Process Sheet

Customer Job Number : CU-DAR001 Dart Helicopters Services

: HINGE BRACKET

DART AEROSPACE LTD	Work Order:	26033	
Description: Hinge Bracket	Part Number:	D2857-1	
Inspection Dwg: D2857 Rev: A1		Page 1 of 1

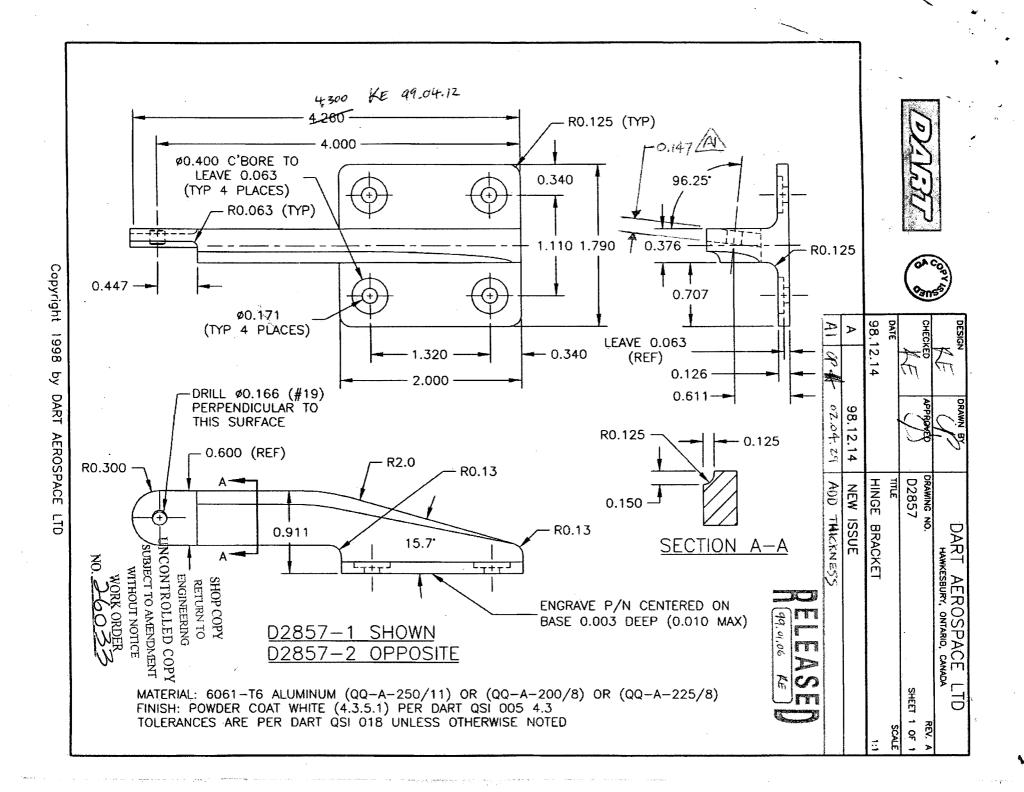
NCR: WORK ORDER NON-CONFORMANCE (NCR)								
		Description of NC		Corrective Action Section B	Verification	A	Approval	
DATE	STEP	Section A	Initial Chief Eng	Action Description Chief Eng	Sign & Date	Section C	Approval Chief Eng	QC Inspector
16013.76	3	1 part dimension . 147 ± .010 is . 135 . 002 under tolerane, is part acceptable?	pt 06.03.27	Port ucuptable por attached D. Shepherd e-mail	JL 06.03.28	16-03-18	06-03.21 06-03.21	06-01-18
								·
							•	Æ

Drawing Dimension	Tolerance	Actual Dimension	Accept	Reject	Method of Inspection	Comments
4.300	+/-0.010	4.301				
0.340	+/-0.010	.341				
1.110	+/-0.005	1.112				
1.790	+/-0.010	1.791	/			
1.320	+/-0.005	1.32/				
2.000	+/-0.010	2.001				
Ø0.171	+0.005/-0.000	0.171				
0.147	+/-0.010	.137			-	see attached e-mai
0.376	+/-0.010	376				
0.126	+/-0.010	./34 .				
0.063	+/-0.010	.067				
Ø0.166	+0.005/-0.000	× 168				
0.911	+/-0.010	, 914				
0.600	+/-0.010	602				
0.125	+/-0.010	. 127	//			
0.150	+/-0.010	-150

```
David
---- Original Message -----
From: "Peter Hum" <phum@dartaero.com>
To: "David Shepherd (E-mail)" <davids@dartaero.com>
Sent: Tuesday, March 28, 2006 2:13 PM
Subject: d2857 deviation
> David,
> I sent you fax showing that the thickness of the D2587-1 is out of
tolerance
> The actual D2857-1 hinge bracket thickness 0.135. The nominal dimension
> 0.147. Therefore, the part is under tolerance by 0.002".
> Is this deviation acceptable?
> Peter Hum
> Mechanical Designer
> DART Aerospace Ltd.
> Email...phum@dartaero.com
> Phone...613-632-3336
> Fax.....613-632-4443
```

Acceptable deviation for this one part. Only 0.002" out of tolerance. Please have them adjust the manufacturing process so that the future parts are within tolerance.
